**RE: MOUNT ATKINSON HOLDINGS PTY LTD**

MAH appreciates the opportunity to review the (Consultation) Draft Metropolitan Waste and Resource Recovery Implementation Plan (Draft Plan) in the context of growth area planning decisions made by the State Government in 2012 to include land west of Hopkins Road within the UGB, nominating its use for a mix of employment / residential and industrial purposes supported by an activity centre.

Figure 3 – Site Plan (SMC)

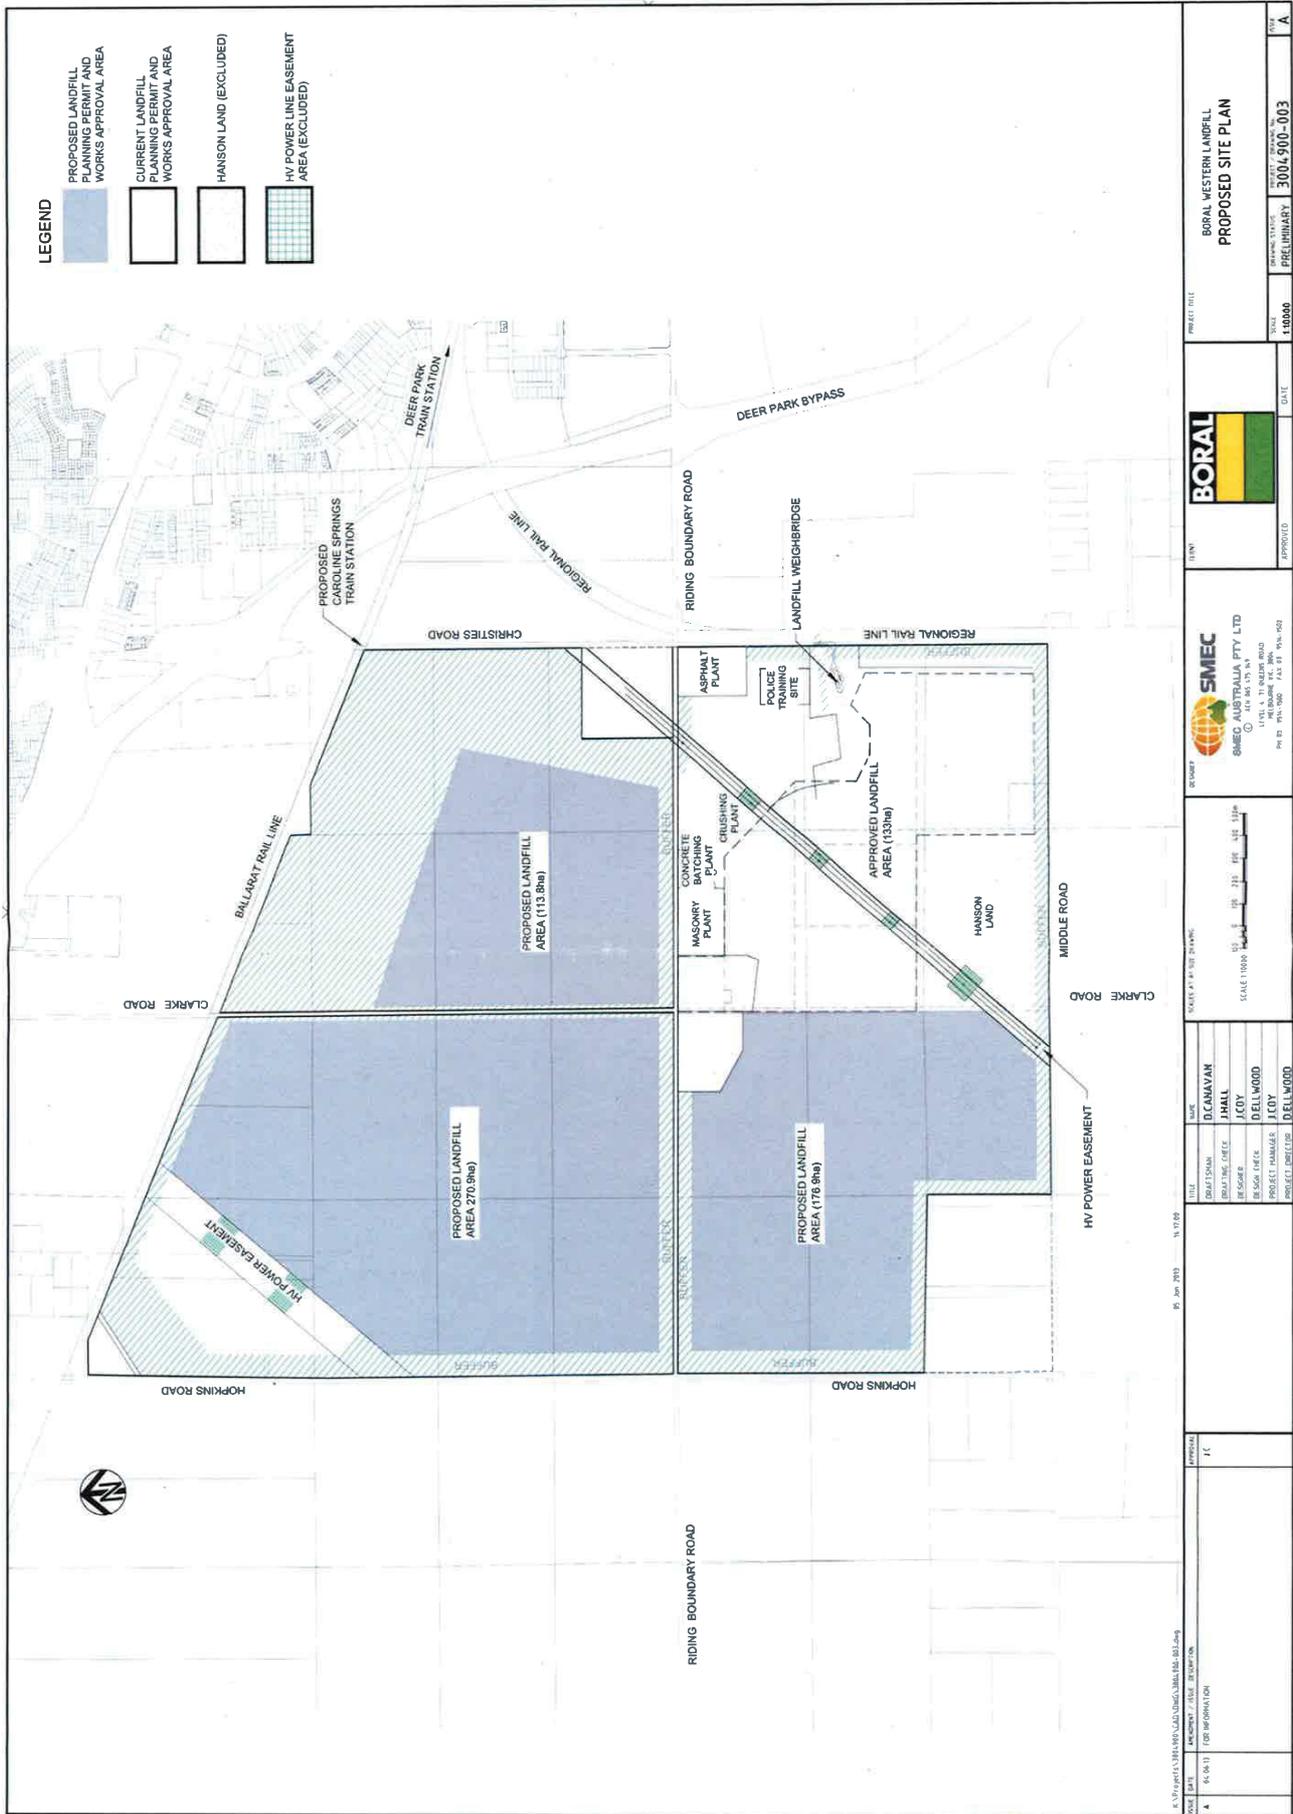
**3. The description of the 'Deer Park Precinct' in Table 13 and depiction graphically on Page 98 are inaccurate both in terms of the extent of the Boral Deer Park WA area and the extent of land approved for landfill.**

The description in Table 13 and the diagram on Page 98 are misleading in the context of the intent and scope of the Draft Plan and the desire for genuine consultation with existing communities currently affected, and potentially affected in the future, by landfill and waste management activities.

The Draft Plan should be amended to accurately reflect the current approval of landfill and waste processing and accurately reflect the area which has approval to be quarried by Boral in the future.

Please refer to the attached diagram which was prepared by Boral depicting the existing conditions at Deer Park.
